1820 BOYLSTON AVENUE

DESIGN RECOMMENDATION #2

MAY 25, 2016

DPD #3020247

NORTH ELEVATION

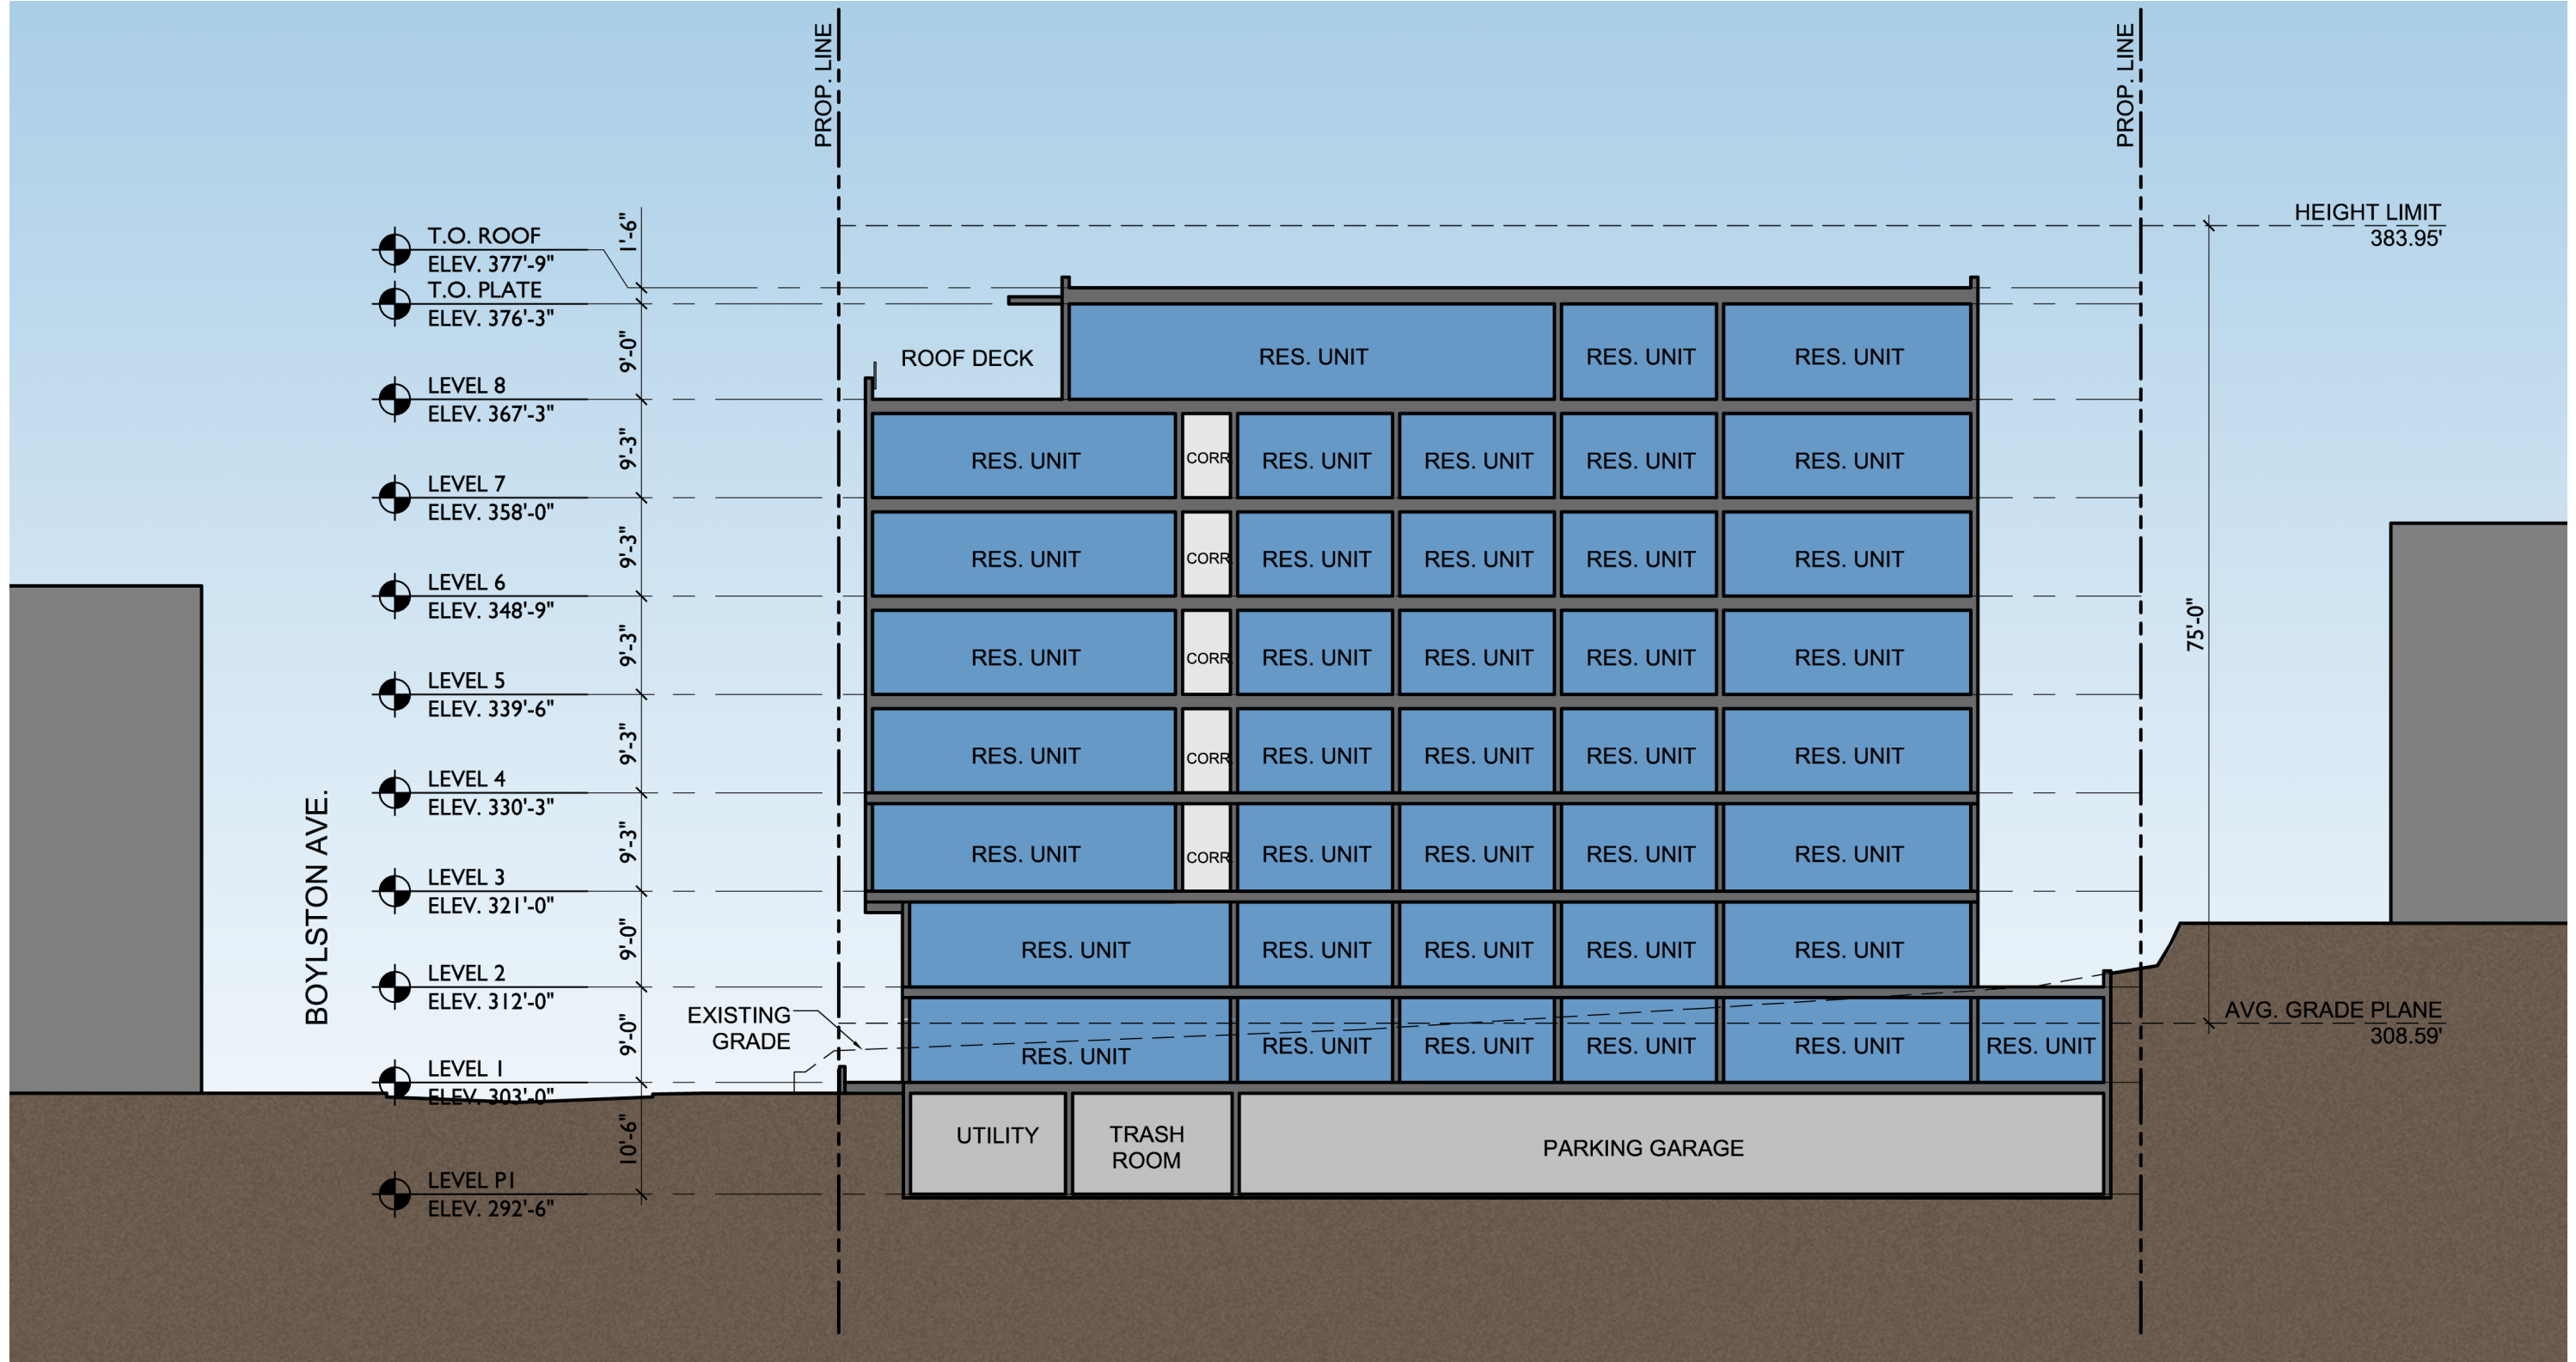
- The board was generally supportive of the material patterns and colors, particularly the lighter color and contrast between the horizontal and vertical orientations of the metal panels
- The board felt that the middle portion of the facade was not well resolved, and recommended that it be more consistent with the design of the rest of the building.
- The board was concerned about the stretches of blank wall, and wanted to see additional softening of the blank walls, particularly at grade where the paved exit path and ramp dominated the ground level.

- The three-part composition of the north elevation has been maintained, using the same material and color palette
- The stairs and elevators have been set back an additional one foot. This simplifies the massing, bringing it in line with the east portion of the building, and providing a greater separation from the neighboring building to the north. The larger setback also allows for additional landscaping along the exit path at grade.

- The east portion of the facade has been extended west, reducing the width of the center portion. The light color metal panel has been maintained, and additional windows have been provided in the east portion to create more transparency and reduce the extent of the blank facade areas.

- At the stair & elevator tower, the parapet above the stair has been aligned with the elevator penthouse, simplifying the massing. The vertical window band at the stair has been moved to the corner, reflecting the corner window treatment on the west elevation.

- Tall plantings have been added at the base of the stair/elevator tower to soften the base of the building along the exit path. Additional landscaping, trees and a water feature have been added at the north side of the lobby.

ENTRY & STREETSCAPE

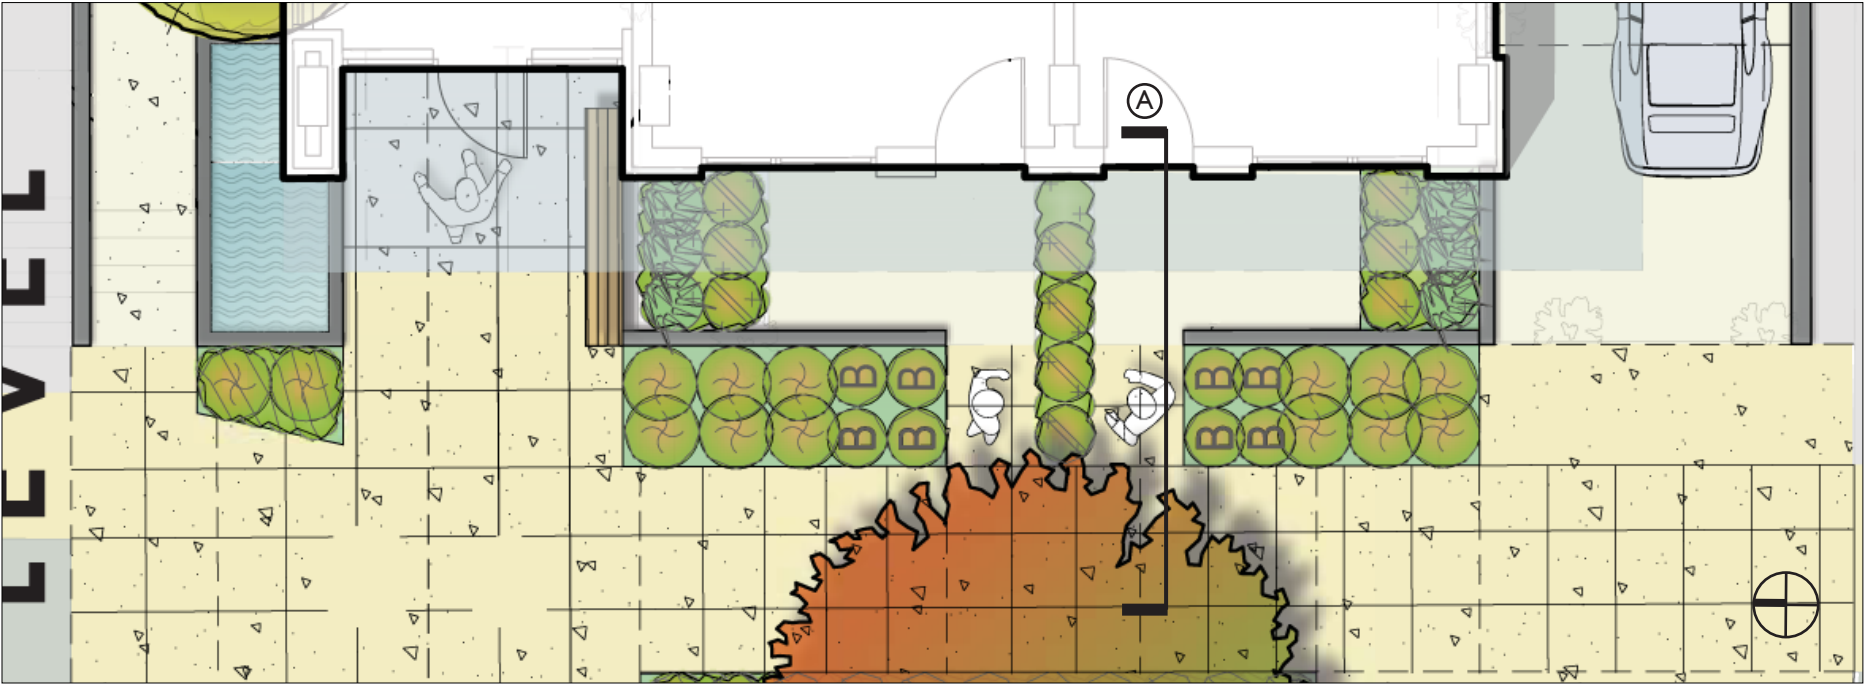
- The board felt that the 2-story base fronting the street was not well integrated with the design of the rest of the building, and recommended that the applicant create more of a relationship between the base and the upper portion of the building.
- The board felt that the treatment of the ground level units was too commercial-looking and too gritty. The board wanted to see a more refined base, providing a more residential character.
- The board was concerned about the privacy of the ground-level units, and wanted to see more development of the landscaping and patios.
- The board felt that the lobby entry was not well articulated and the entry path was unclear, particularly due to the grade difference between the entrance and the sidewalk and the exterior concrete column.

- The distinct base, recessed from the massing above, has been retained, as it helps to break up the massing vertically and reflects the two-story units and lobby at ground level. The upper portion of the building has been pulled back 2'-6" from the property line to improve the relationship between the upper and lower massing.

- Cor-ten steel cladding has been replaced with dark brick, providing for a more refined texture that is more consistent with the neighborhood context. The vertical brick columns reflect the vertical accent bands of the building above. Concrete planter walls with wood caps are integrated into the exterior walls, forming the base of the brick columns.

- The ground floor elevation has been raised to make the entry lobby level with the sidewalk, and creating raised stoops at the residential patios. The raised patios help to create a more residential character and reinforce the privacy of the patios. The sunken entry court and ramp have been eliminated and replaced with additional landscaping and a water feature.

- The windows at the residential units have been broken up into smaller units, using the same window system as the residential units above, creating a more residential and human-scaled facade. Small canopies have been added over the residential entries to reinforce this character.

- The lobby has been pulled closer to the sidewalk, and the corner column has been integrated into the building facade. Building signage has been integrated into the facade above the main entry where it will be more prominent. A larger canopy provides additional emphasis to the residential entrance.

SOUTH & EAST ELEVATIONS

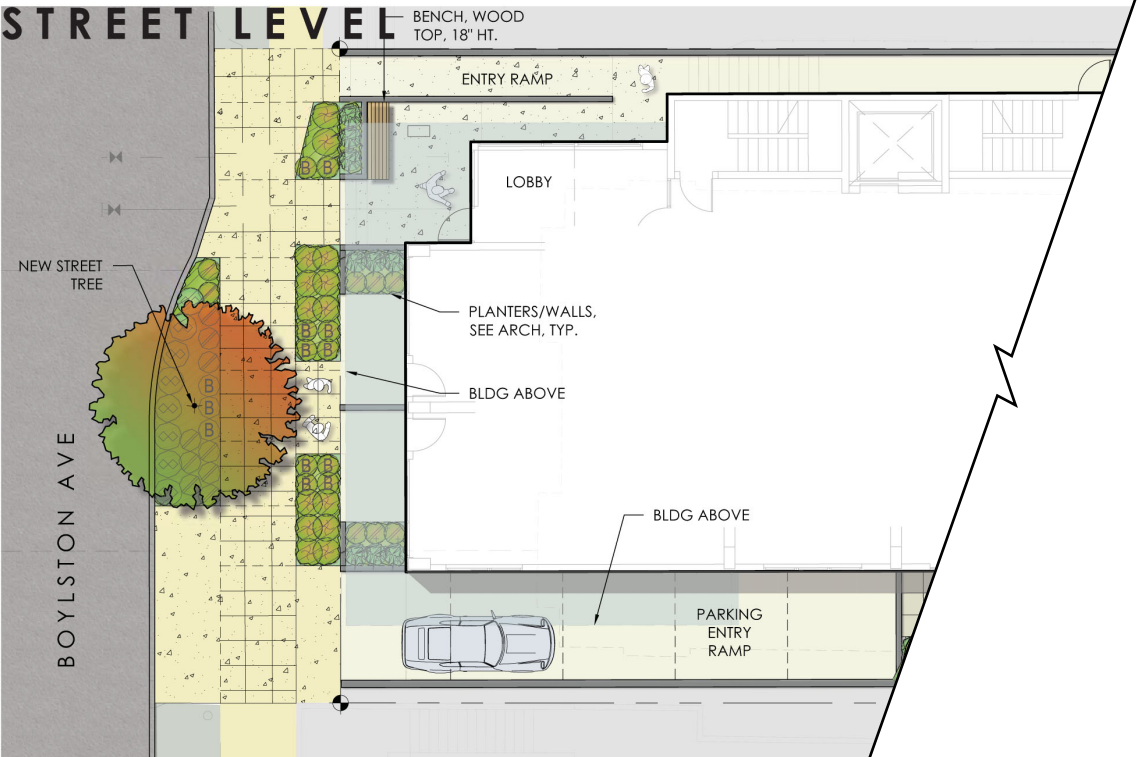
The board was supportive of the design of the south and east elevations. In the revised design, the south elevation has a slight reduction of windows to account for the additional setback of the west facade. The east elevation has been kept the same as proposed at the first recommendation meeting, with minor window adjustments in response to changes of the west facade.
